To: John Tunstall
From: Jeff Walton, Associate Planner; 910-341-3260
CC: File; Protrak
Date: 12/2/2013
Re: Planning Comments

The following is a list of comments for review from planning regarding the project. Please provide your corrections as listed below. Additional review will be required once all the needed documents have been provided. Items or documents not provided on initial submission will be subject to further review. Please contact me for any further questions.

QUESTIONABLE TREE REMOVAL eXAMPLE

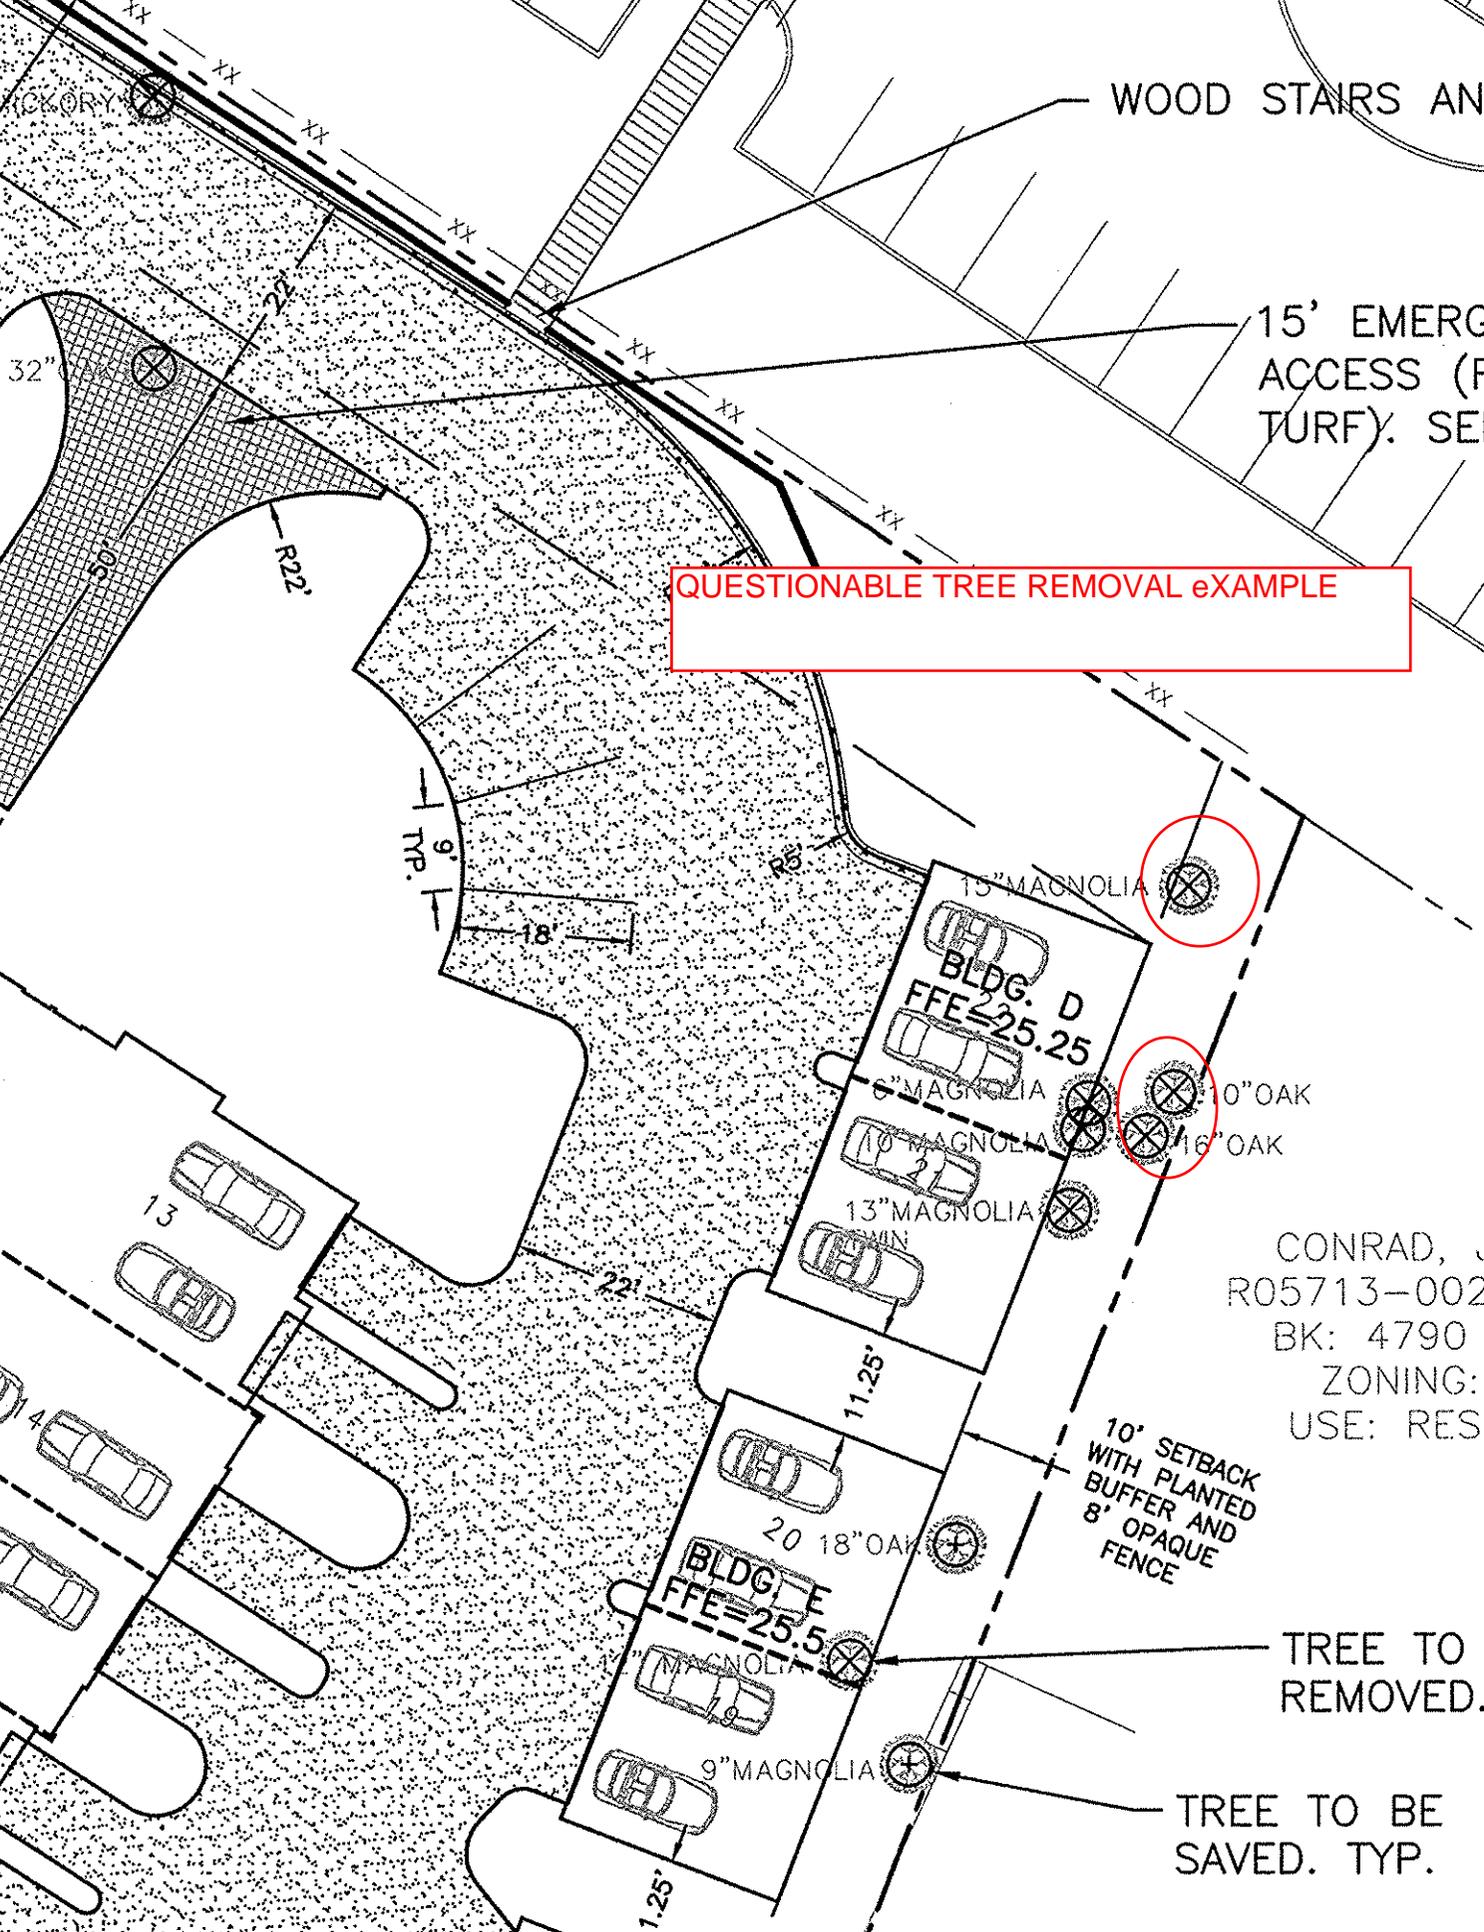
- I have added an attachment showing questionable trees to be removed.

TREE TO REMOVED.
